**PLANNED UNIT DEVELOPMENT &
PLANNING APPROVAL STAFF REPORT****Date: June 1, 2006****NAME**

Mike & Daphne Sullivan and Delmas & Sue Whatley

LOCATION4161 Dauphin Island Parkway
(East side of Dauphin Island Parkway, 190'± North of Terrell Road).**CITY COUNCIL
DISTRICT**

Planning Approval to allow a recreational vehicle park in a B-3, Community Business district, and Planned Unit Development Approval to allow multiple buildings on a single building site.

SITE PLAN

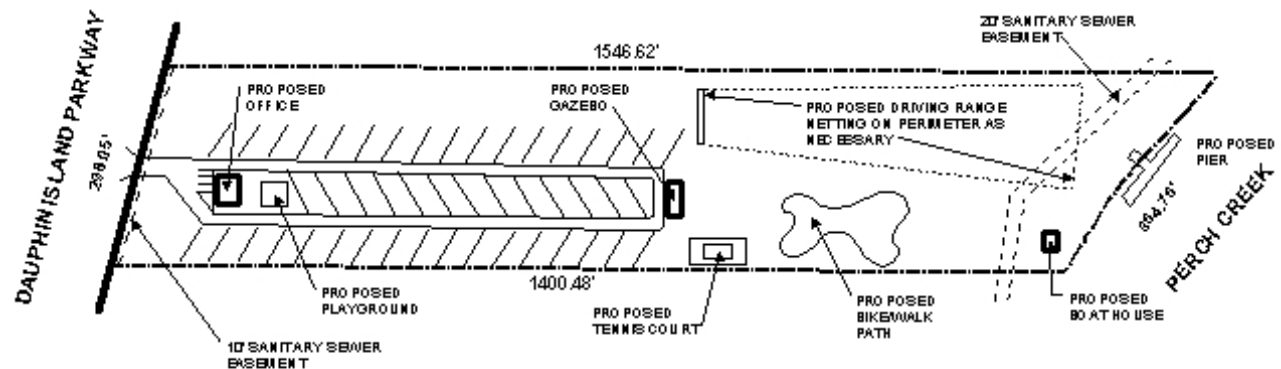
The proposed one-way circulation system, with a pavement width of 15-feet, seems inadequate for the movements that will be required for the larger RVs to turn or back-into proposed parking spaces. It would also appear that the turning radius may not be adequate to assure that the larger RVs will not cut the corners when making the turn to return to the front of the property. The circulation system also does not appear to be designed to allow a large RV to circle around the office structure if necessary to return into the RV parking area. Other circulation on the site is not depicted, specifically, how users of the various facilities on the property will get from place to place – no pedestrian paths to the boat house or other facilities are indicated. It is also assumed that the operators of the RV park would periodically need vehicular access to the boat house and pier area, thus some sort of drive or access route should be depicted on the site plan.

The site abuts existing residences to the South. Because the site is zoned commercially and abuts residential uses, a protection buffer in conformance with Section 64-4.D. is required. The required protection buffer may be a 10-foot wide planting strip or a six (6) feet high privacy fence (except for the portion of the fence within the 25-foot setback line, which can only be 3-feet tall). The site plan should be revised to depict the required protection buffer.

It is anticipated that lighting will be provided on the site. Any lighting provided must comply with Section 64-4.A.2. of the Zoning Ordinance, and not shine directly into adjacent residential areas or into traffic. The site plan should be revised to depict any exterior lighting, and information provided to staff regarding selected lighting fixtures in order to ensure conformance with the lighting requirements of the Zoning Ordinance.

Many RV parks provide additional facilities such as sanitary dump stations, power and water hookups, and in some cases propane. The detailed plan depicting the two proposed types of sites indicates that sewer, water and electrical hookups will be provided. Additional information should be provided regarding the proposed sewer hookup facilities, specifically, if these facilities will be connected to public sewer facilities, or if they will be connected to a centralized on-site collection facility which is periodically serviced. If a centralized facility is provided, it should be depicted on the site plan.

The unpaved RV parking is of concern as Section 64-6.3.a. of the Zoning Ordinance, with few exceptions, requires paved parking areas. While use of gravel at a campsite may be compatible with the natural surroundings, the fact that modern RVs (Class A motorhomes) can exceed 30,000 pounds (15 tons) gross vehicular weight is of concern as it relates to the longevity and appropriateness of gravel parking areas. Furthermore, any other “by-right” uses allowed within a B-3 district would be required to provide paved parking. Therefore, it is recommended that all RV parking areas be paved, in conformance with the Zoning Ordinance.

There is no indication on the site plan as to the proposed location of any dumpster or other waste storage facility. If the applicant utilizes a dumpster, the location of the storage area for the dumpster must be indicated on the site plan, and the location and required screening must comply Section IV.D.9. of the Zoning Ordinance, as well as with all other applicable regulations.

Planning Approval: Based upon the preceding, this request is recommended for Holdover until the July 6th meeting to allow for the provision by June 14th of the following items: 1) documentation that the vehicular circulation system is adequate for a Class A motorhome and/or fire apparatus, or revision of the site plan to provide adequate turning radius as needed, including return circulation around the office/bath building; 2) depiction of any other on-site circulation systems, including pedestrian paths or service roads for access to the rear of the property; 3) depiction on the site plan of any required stormwater

detention facility; 4) depiction of the protection buffer required by Section 64-4.D. of the Zoning Ordinance; 5) depiction of any proposed outdoor lighting on the site plan, and provision of information to staff adequate to determine compliance with Section 64-4.A.2. of the Zoning Ordinance; 6) depiction of any centralized sanitary waste storage facility on the site plan, or confirmation that all sewage will be removed from the property via public sanitary sewer; 7) revision of the site plan to depict all RV parking areas as paved areas, designed in conformance with Section 64-6. of the Zoning Ordinance; 8) depiction of any dumpster storage facilities on the site plan; and 9) revision of the legal description to reflect the existing recorded plat.
